Public Comment No. 974-NFPA 70-2021 [Global Input]

First Revision No. 9274-NFPA 70-2021 [Global Input]

Correlating Committee Definitions Task Group

CMP-12 - Definitions

Figure Informational Note Figure 620.1, No. 5 Control System.

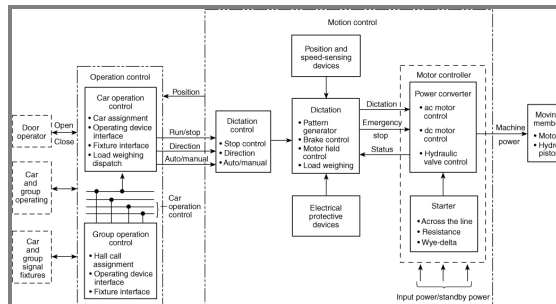
The Correlating Committee advises that article scope statements are the responsibility of the Correlating Committee and directs the Panel to revise the Informational Notes to comply with 4.1.3 of the NEC Style Manual.

Committee Statement: The Correlating Committee advises that article scope statements are the responsibility of the Correlating Committee and directs the Panel to revise the Informational Notes to comply with 4.1.3 of the NEC Style Manual.
